QUAD CITIES NUCLEAR POWER STATION UNIT 1

AMENDMENT TO FACILITY OPERATING LICENSE

Amendment No. 61
License No. DPR-29

ATTACHMENT TO LICENSE AMENDMENT NO. 61

FIGURE 3.5-1
(Sheet 1 of 6)

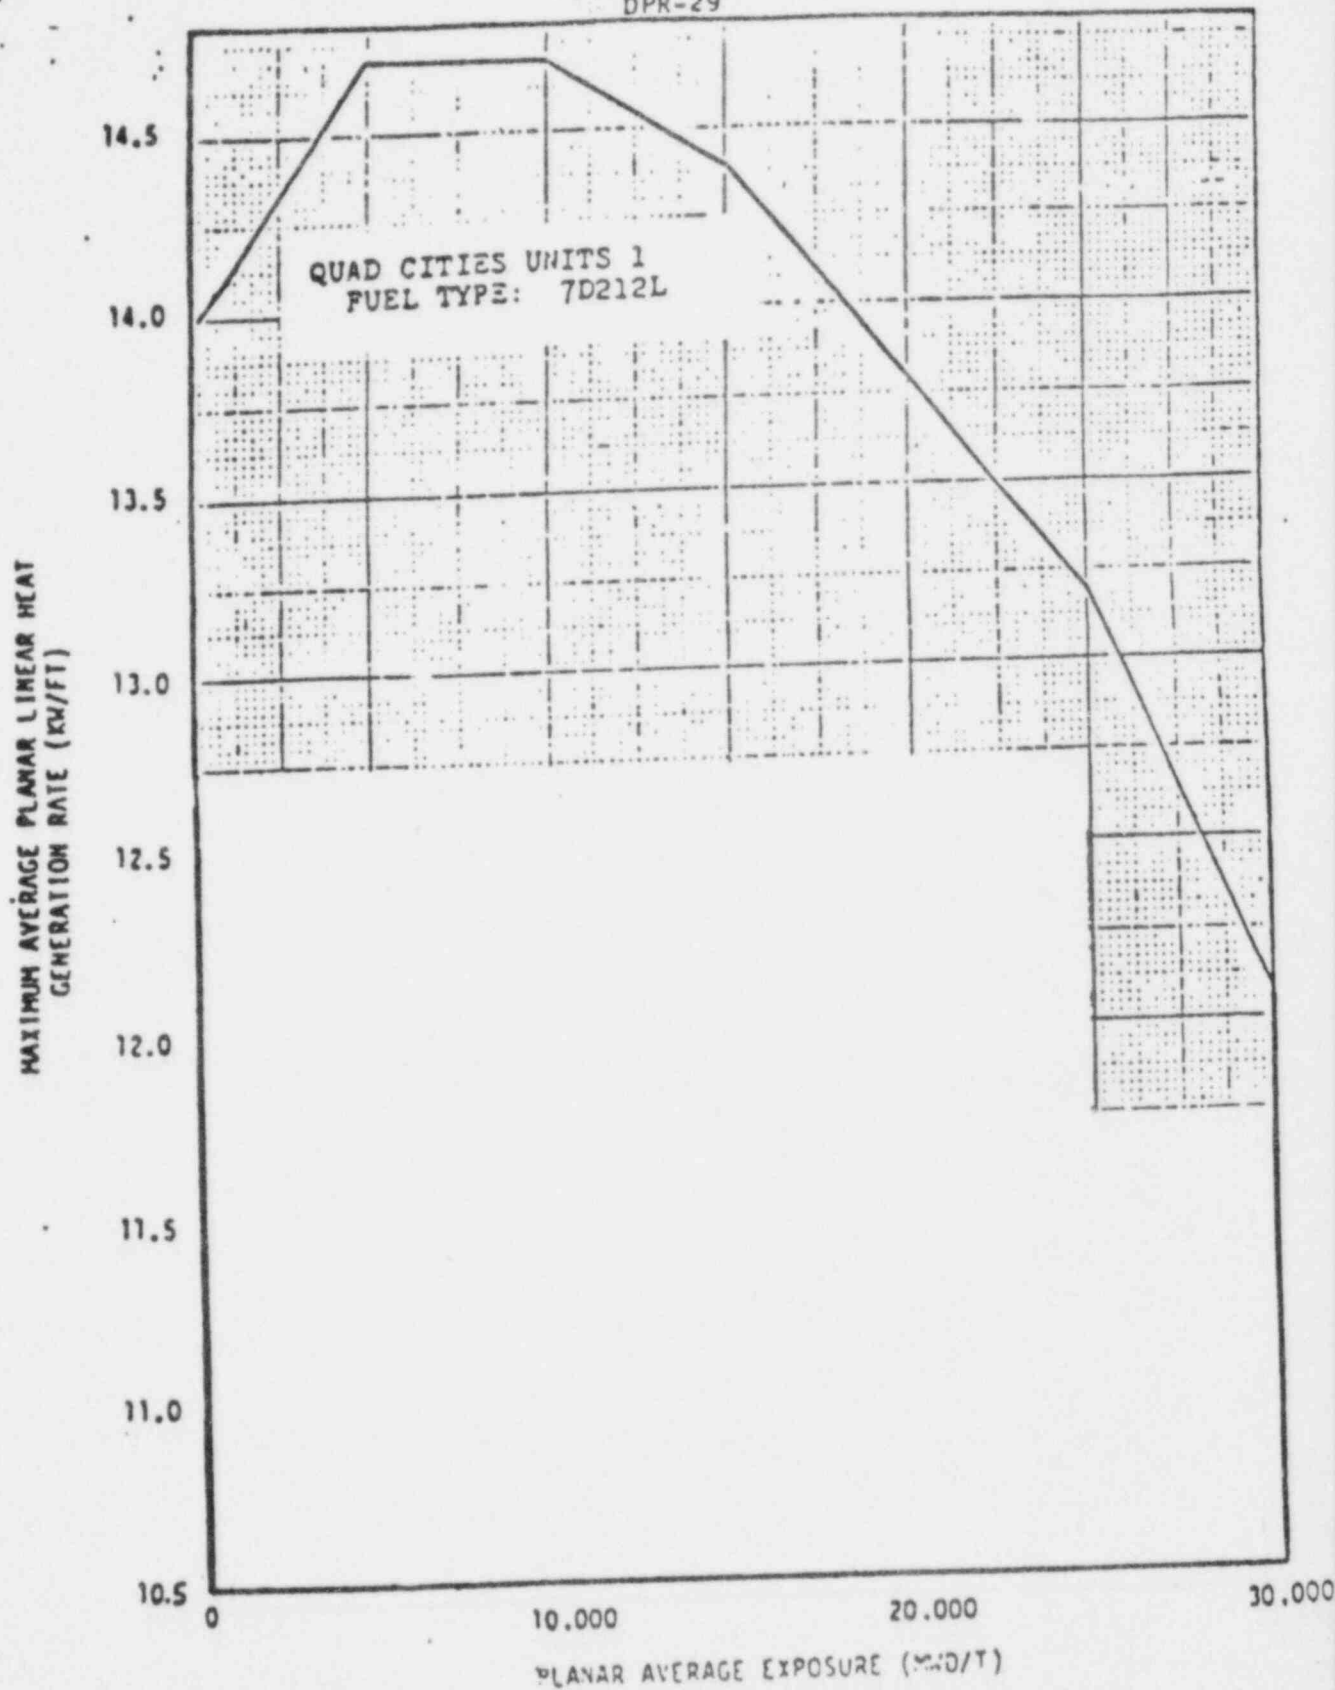
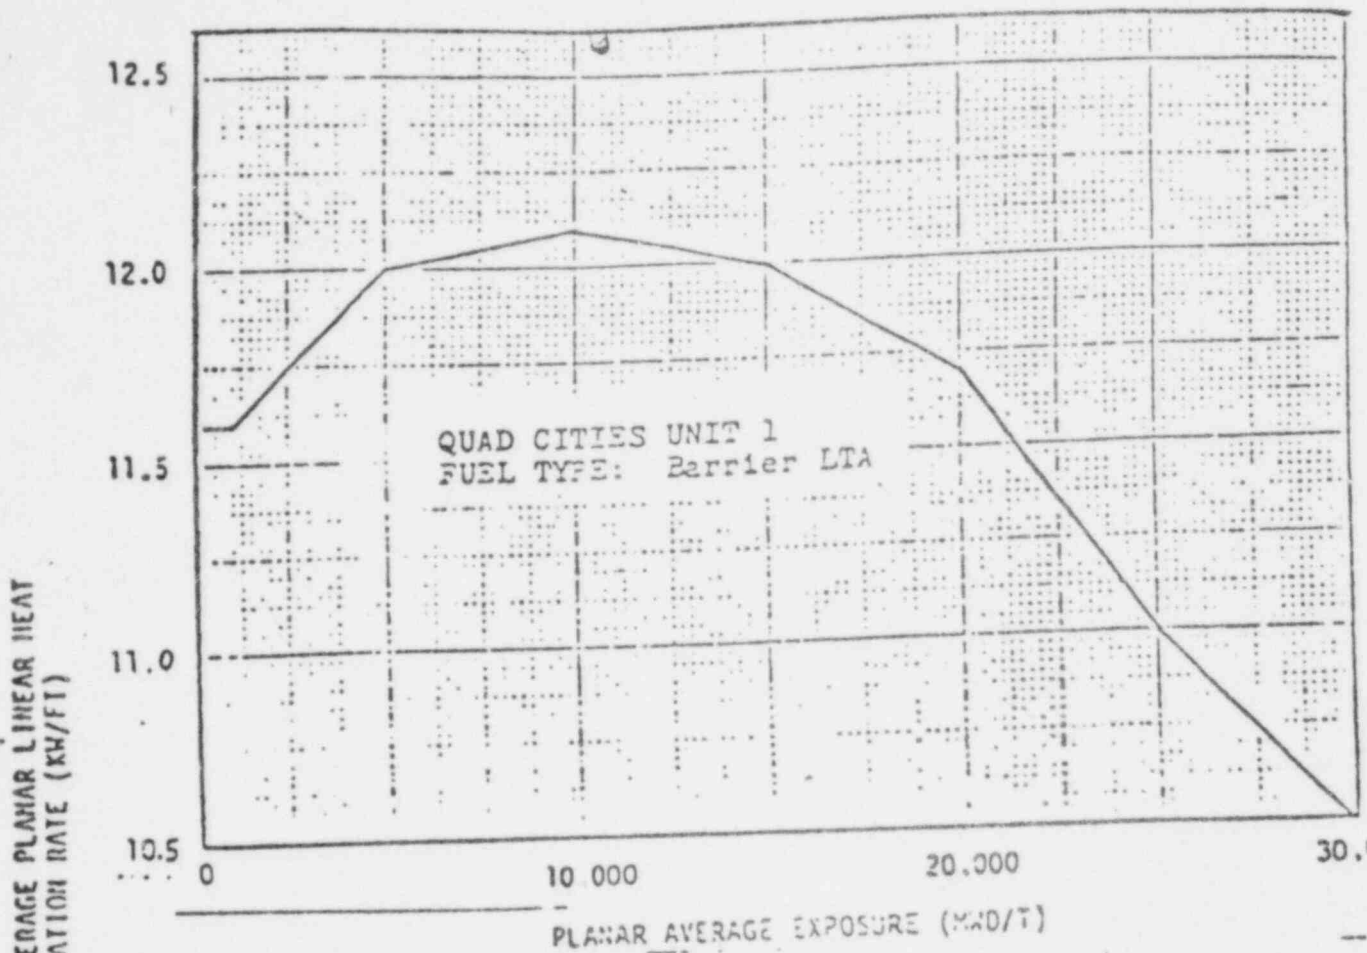
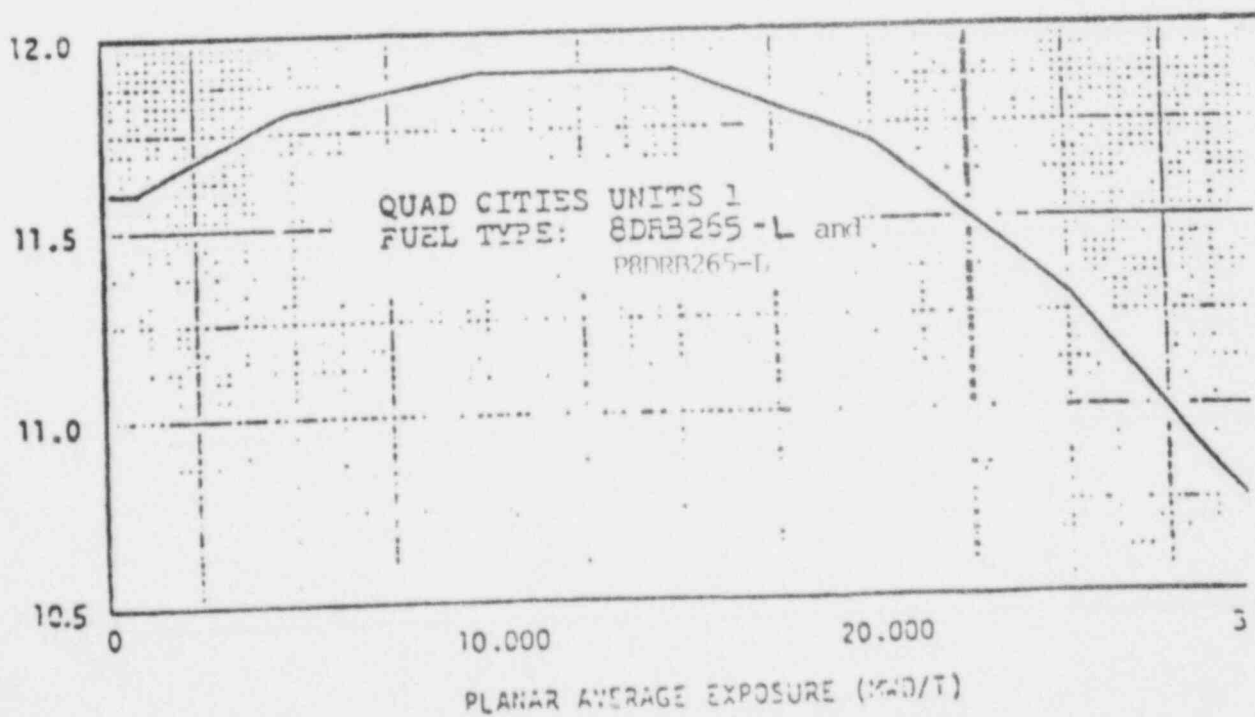
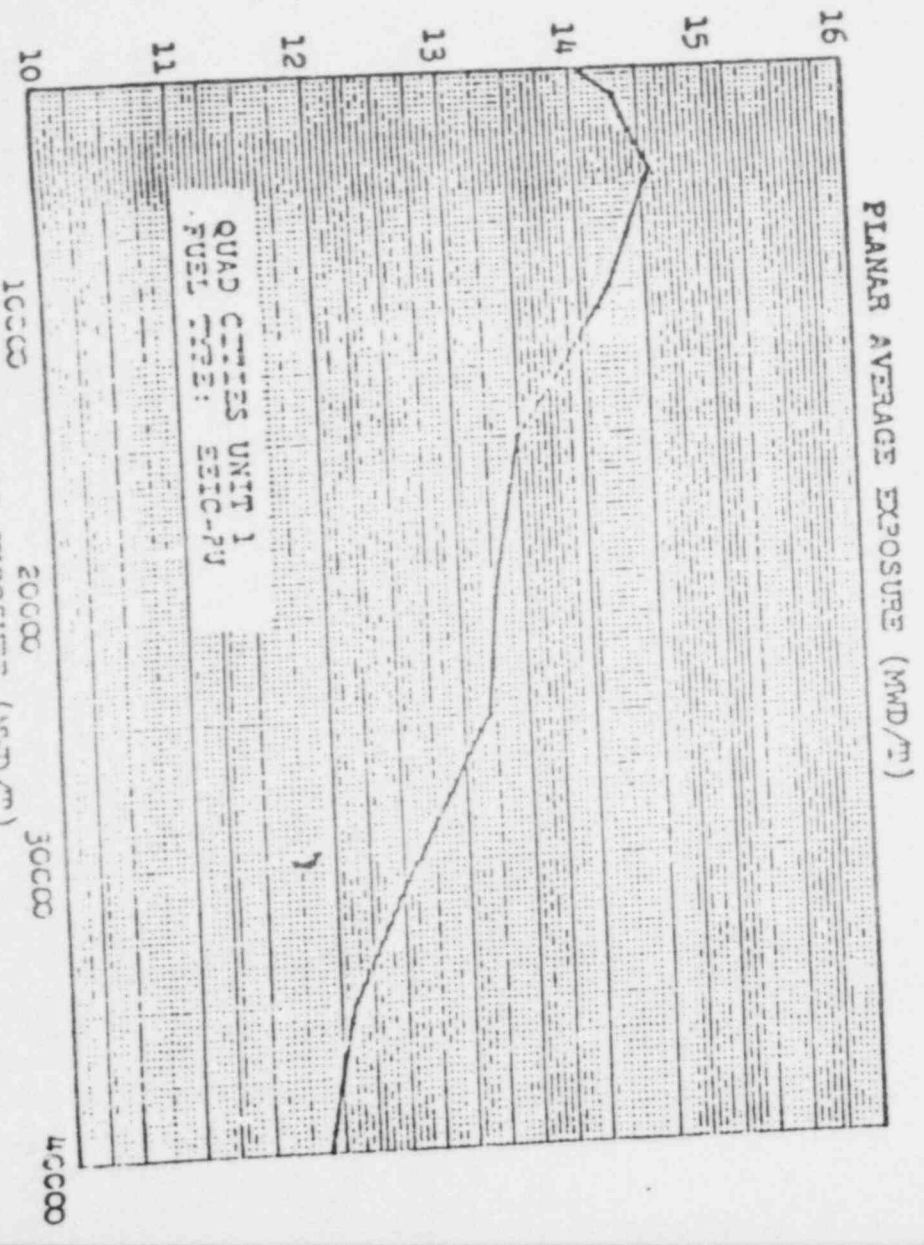
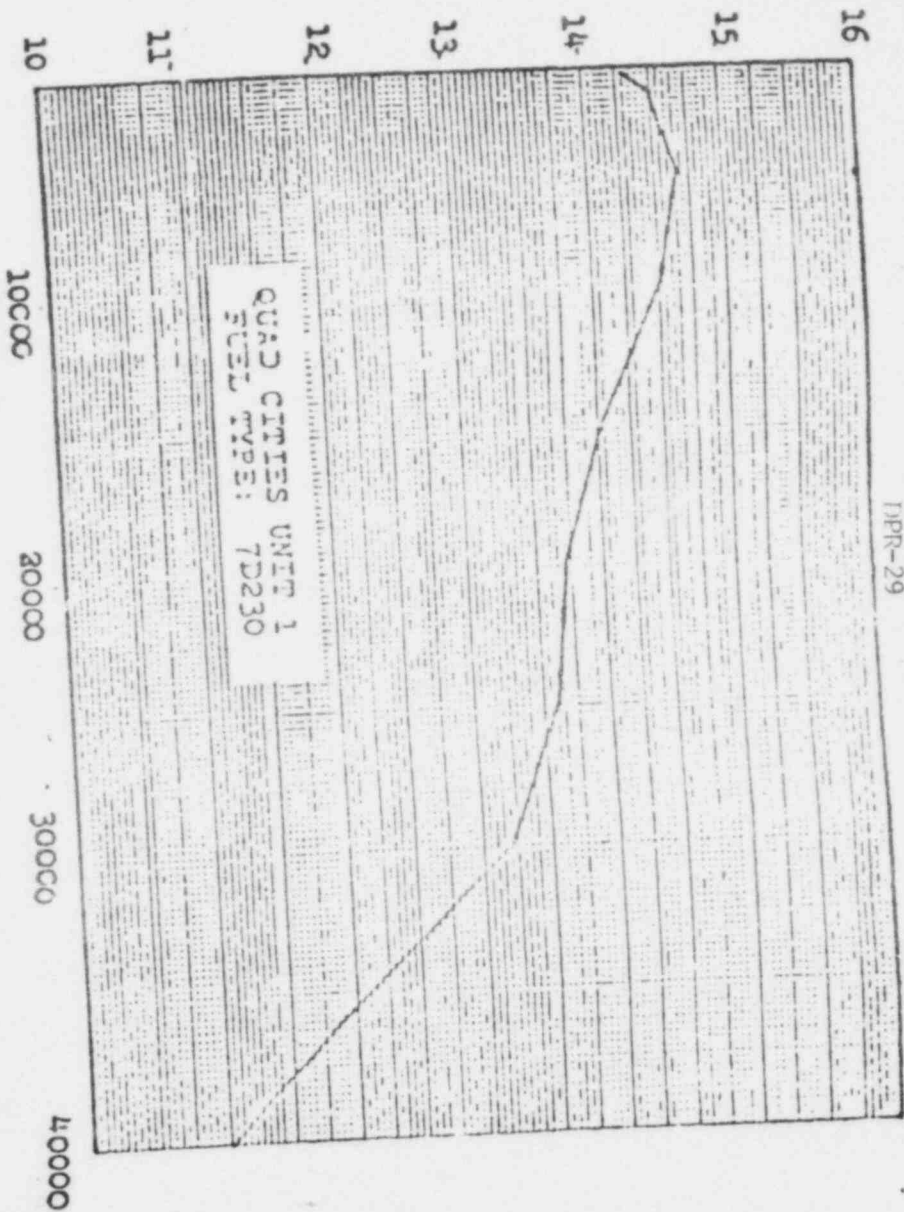
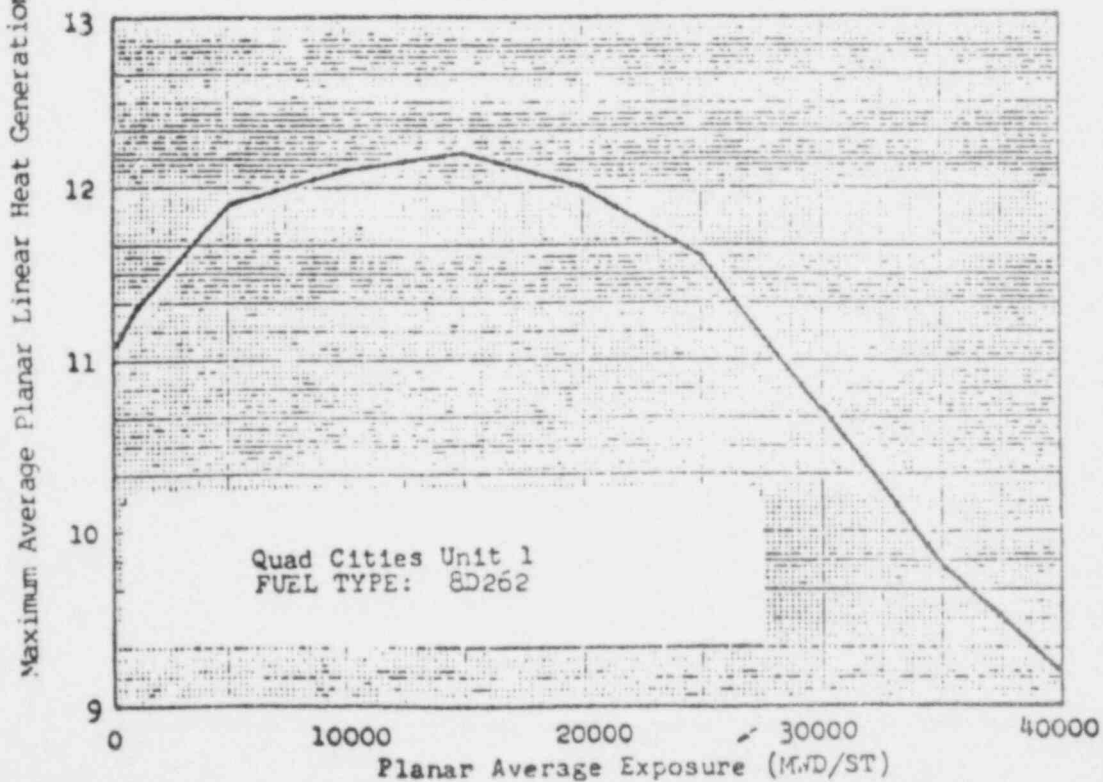
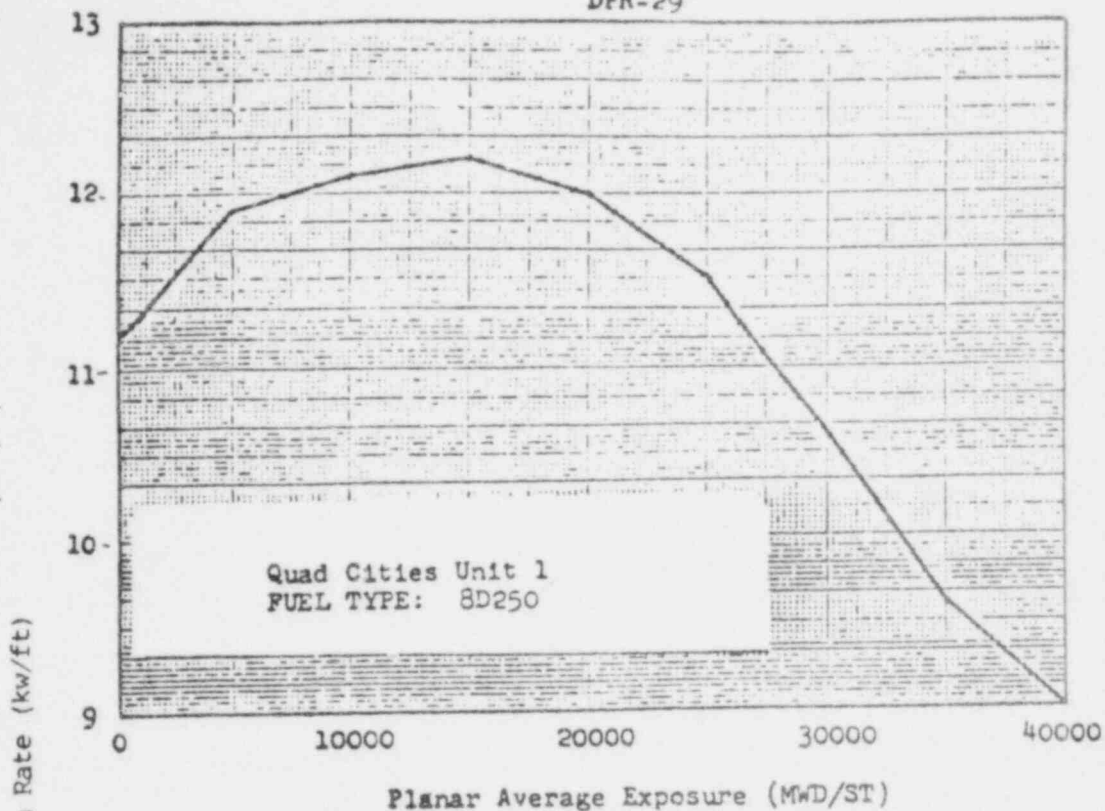
2. Page 1.1/2.1-2a is added.
3. Figure 2.1-2 is deleted.
4. Figure 3.5-1 is being replaced by 6 pages.

During steady-state power operation, the average linear heat generation rate (APLHGR) of all the rods in any fuel assembly, as a function of average planar exposure, at any axial location, shall not exceed the maximum average planar LHGR shown in Figure 3.5-1.

The peak cladding temperature following a postulated loss-of-coolant accident is primarily a function of the average heat-generation rate of all the rods of a fuel assembly at any axial location and is only secondarily dependent on the rod-to-rod power distribution within an assembly. Since expected local variations in power distribution within a fuel assembly affect the calculated peak cladding temperature by less than ±20°F relative to the peak temperature for a typical fuel design, the limit on the average planar LHGR is sufficient to assure that calculated temperatures are below the limit. The maximum average planar LHGR's shown in Figure 3.5-1 are based on calculations employing the models described in Reference 2.
